CITY OF SARATOGA SPRINGS
DESIGN REVIEW COMMISSION

Design Review Commission Meeting – Wednesday, November 16, 2016

A. 2016.075 Obstarczyk Garage Demolition

147 Spring Street, Advisory Opinion to ZBA on the demolition of a contributing structure and reconstruction of a garage within the Urban Residential-3 District.

147 Spring Street

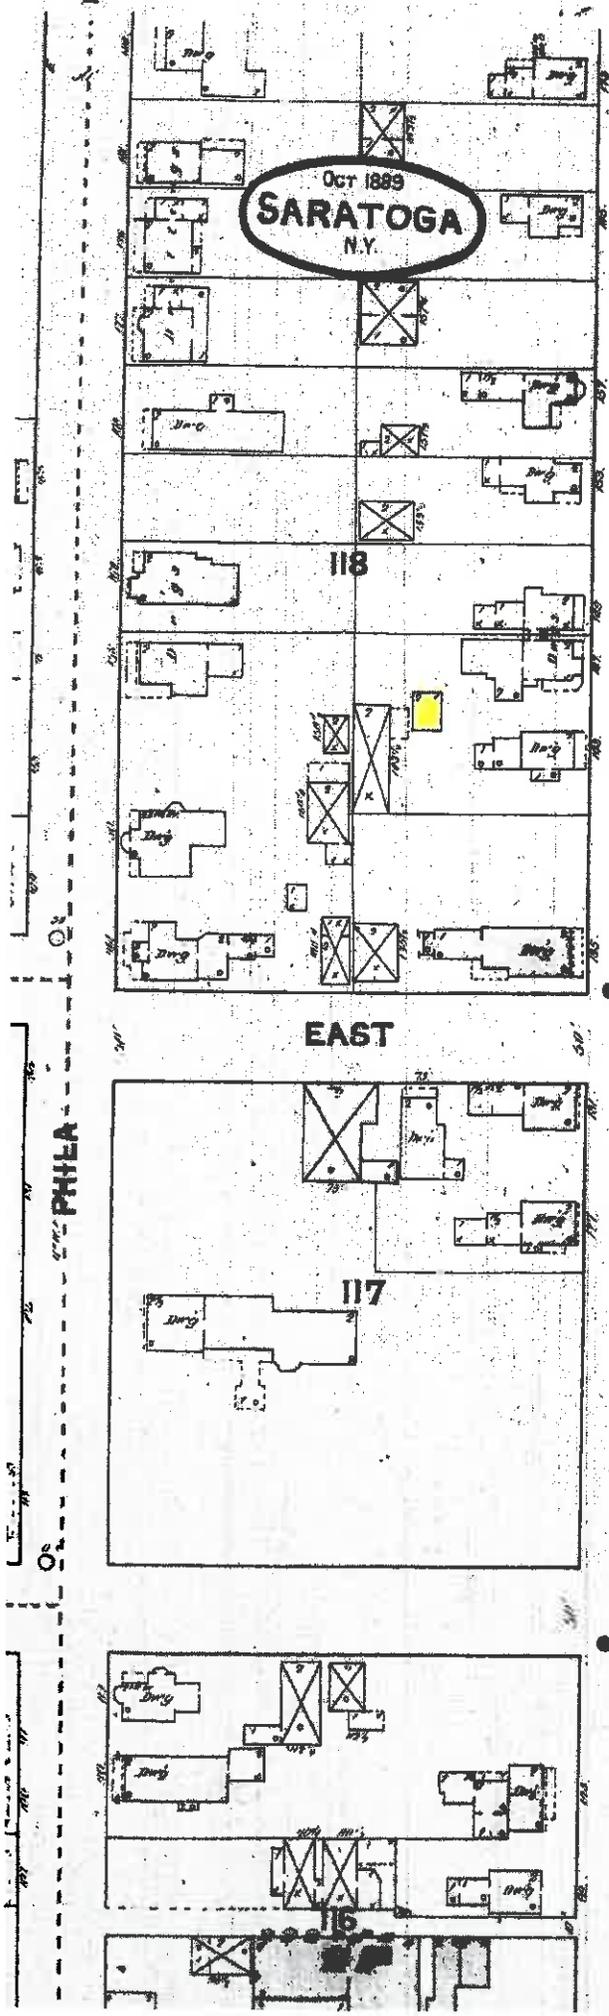
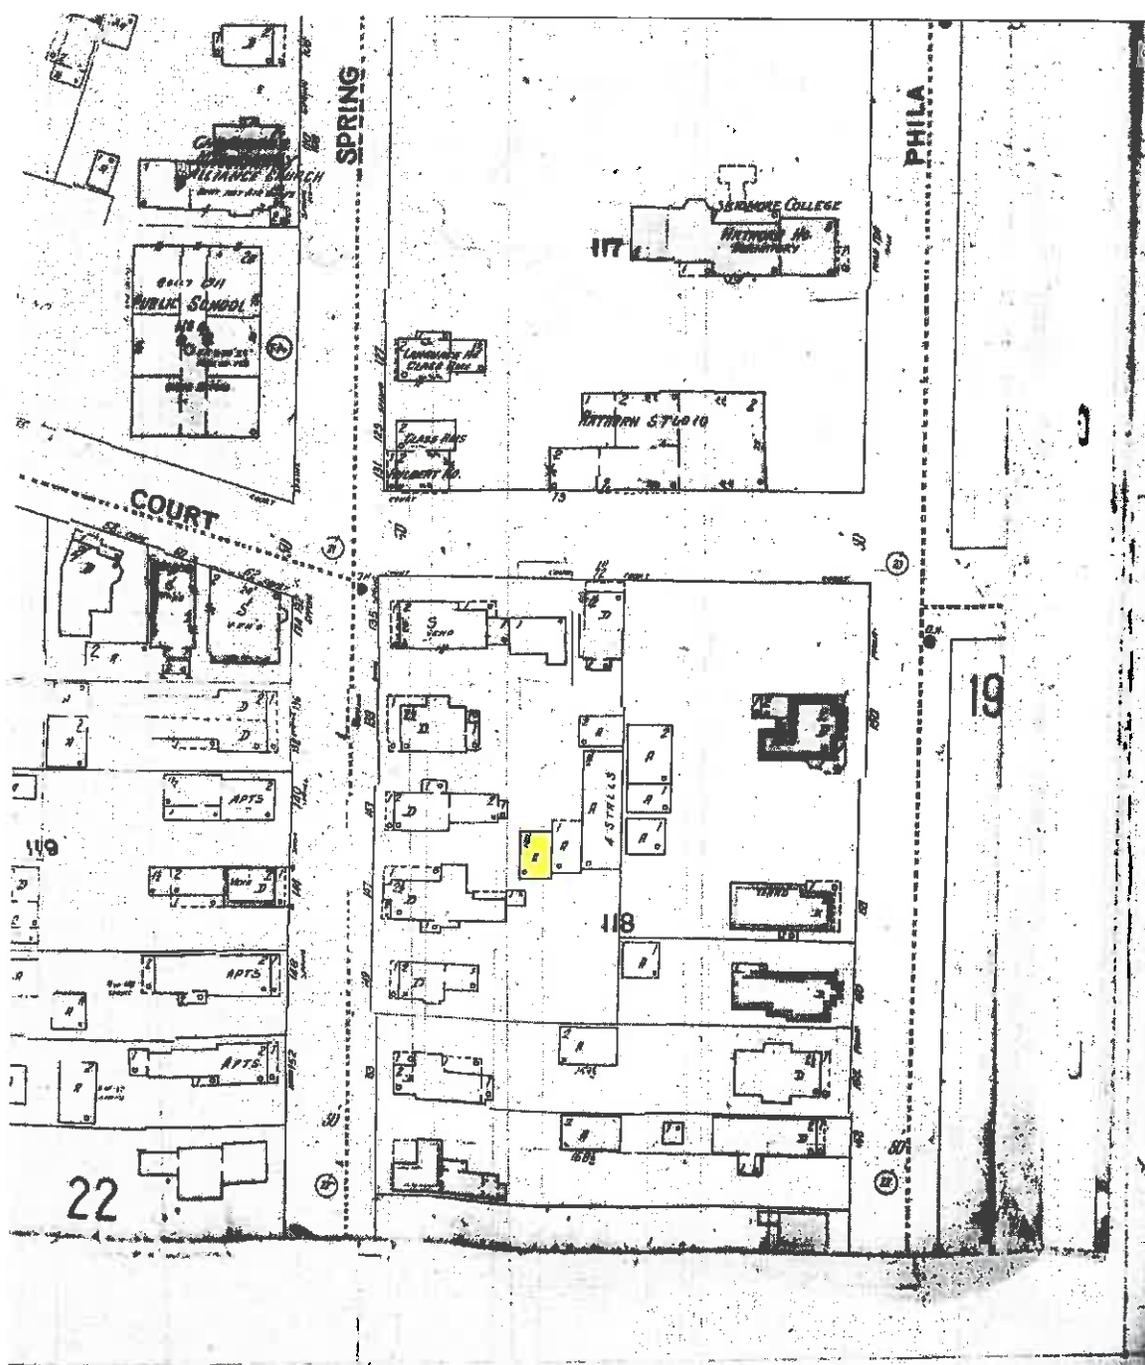
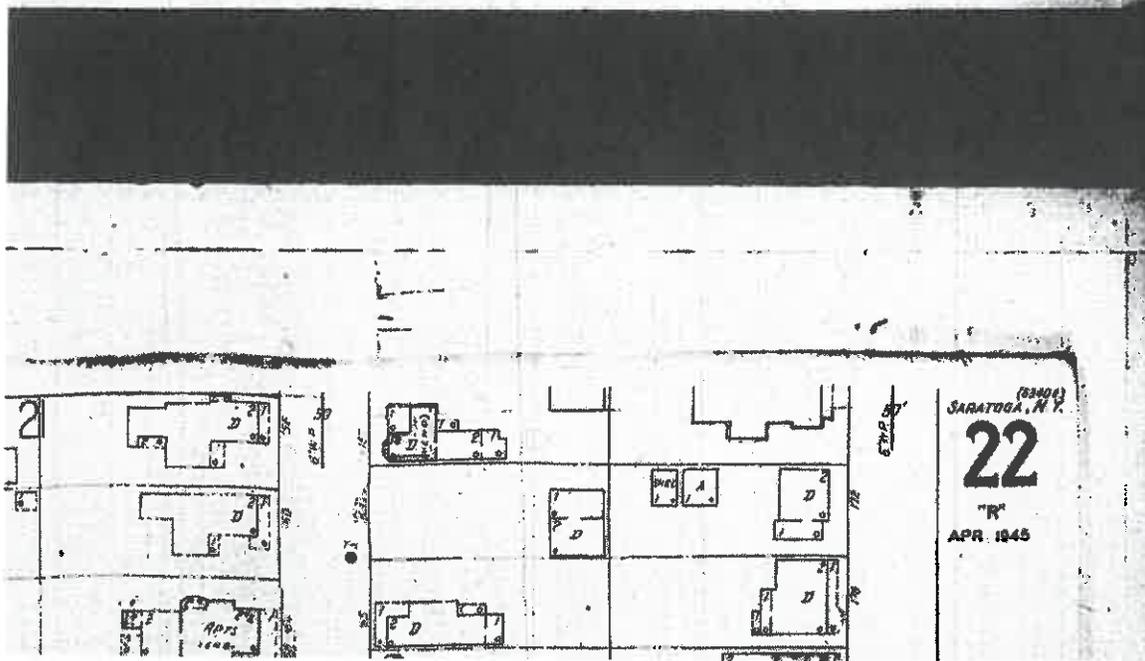
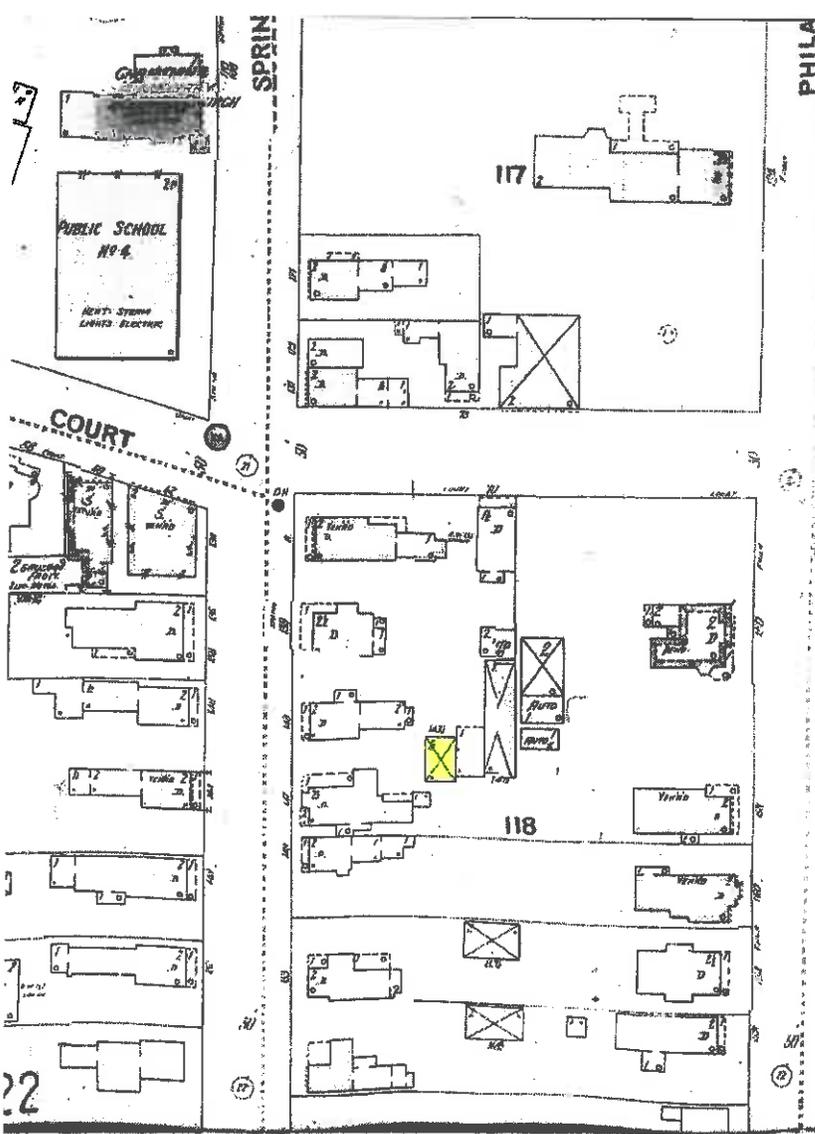
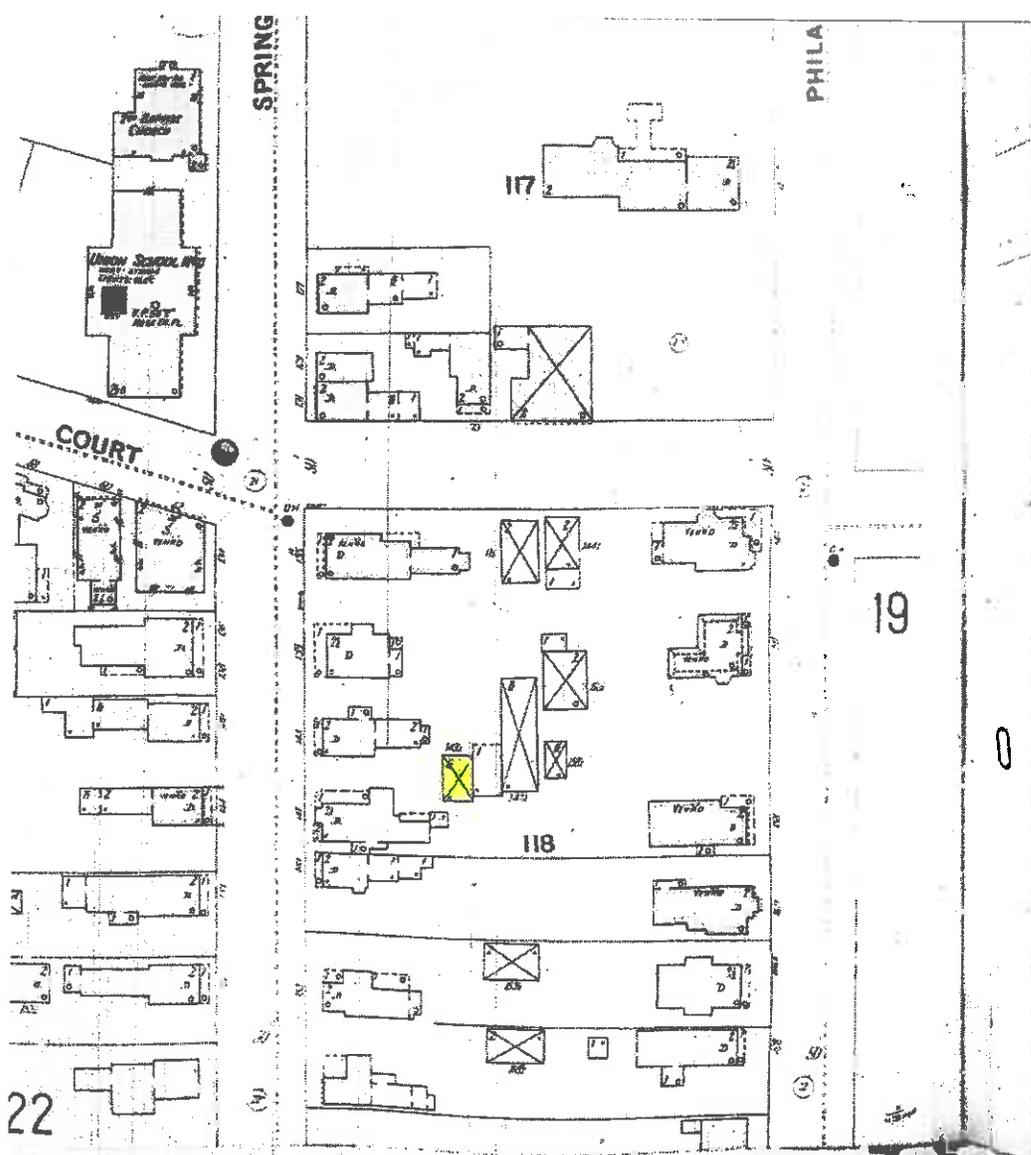
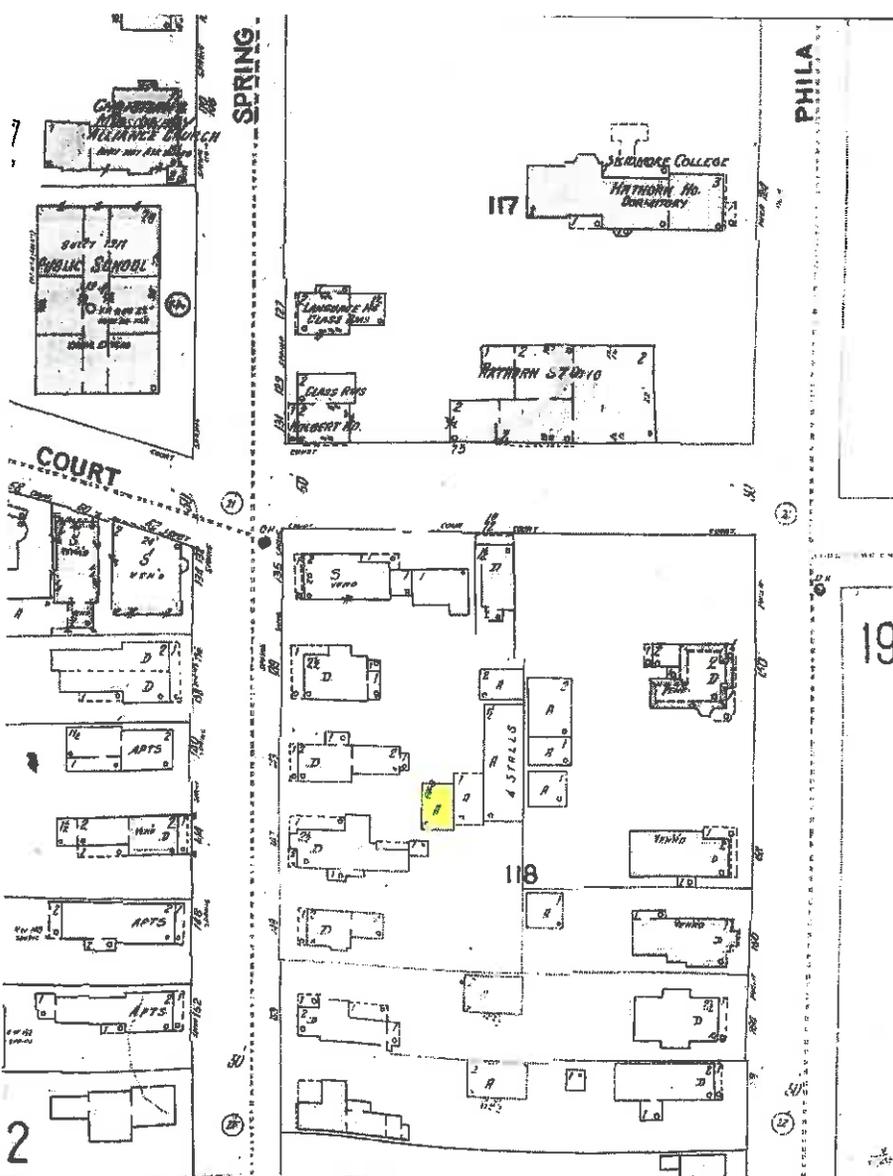
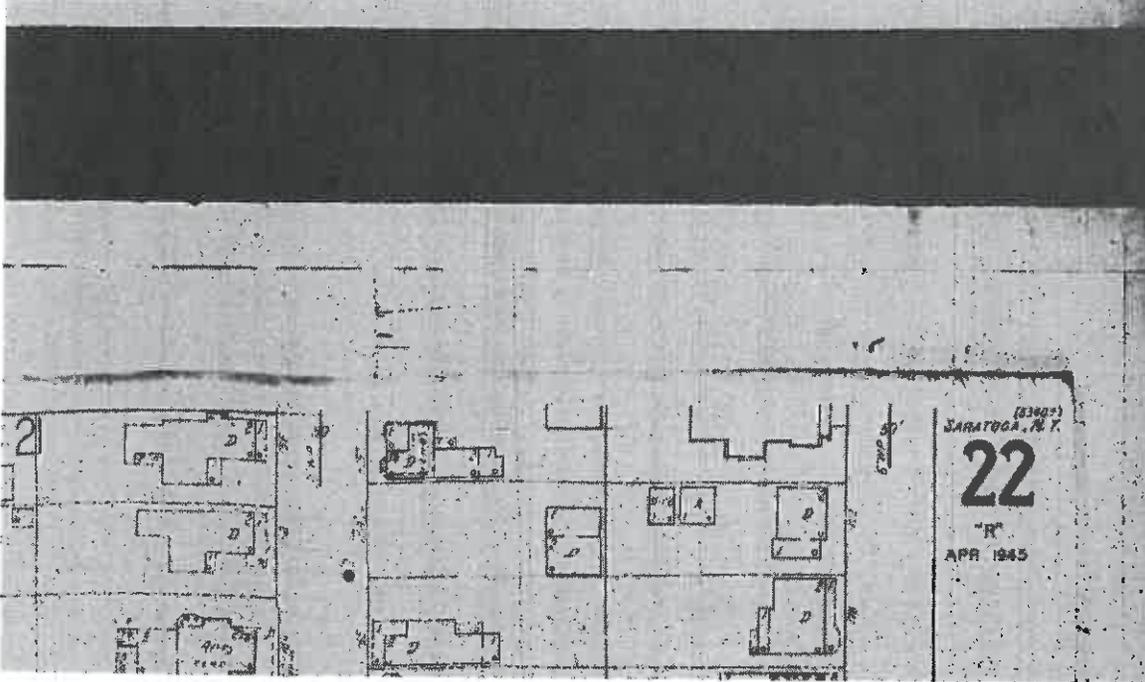
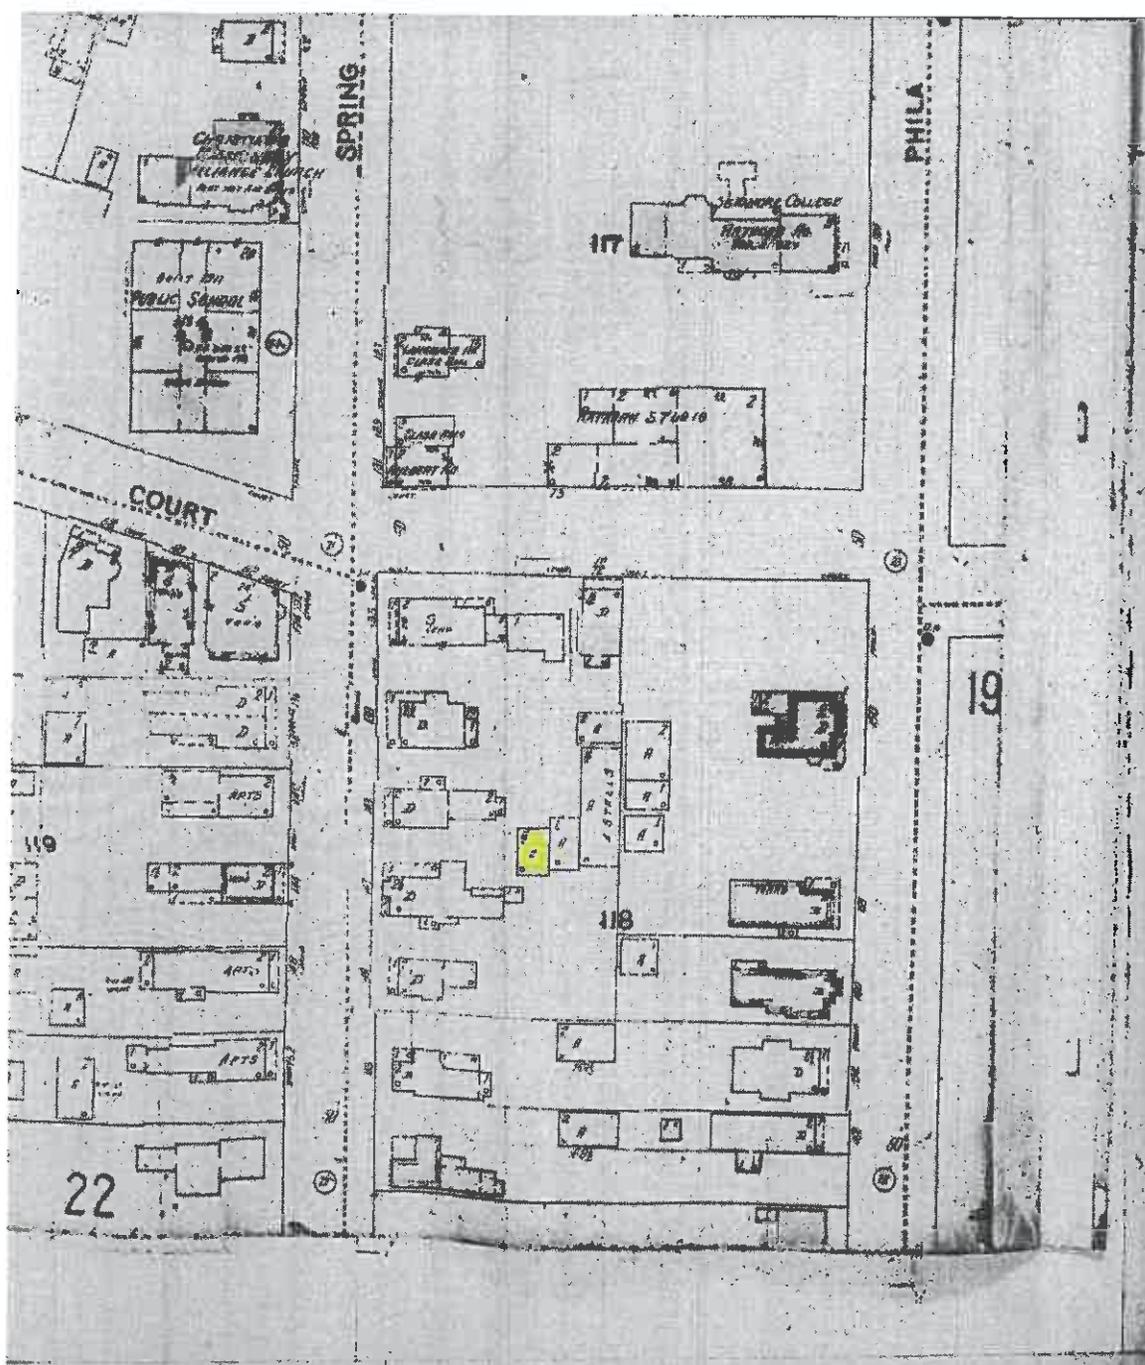
The Queen Anne style house located at 147 Spring Street was constructed circa 1867. Research indicates that the house originally shared the lot with 143 Spring Street and had three accessory buildings, including a large stable. The structure that the applicant is proposing to demolish was constructed between 1876 and 1888 when it first appears on the 1888 Burleigh Bird's Eye View Map. Please see enclosed documentation. The accessory structure at 147 Spring Street is the *only one* of the accessory structures that remains from the two properties. Both the house and the accessory structure are "contributing buildings" to the East Side Historic District listed on the National Register of Historic Places.

The Foundation objects to the demolition of the historic accessory structure. Historic carriage houses, stables, and other accessory structures throughout Saratoga Springs are threatened with demolition-by-neglect and removal. They are important cultural resources of the history and development of our community and should be preserved to the fullest extent possible.
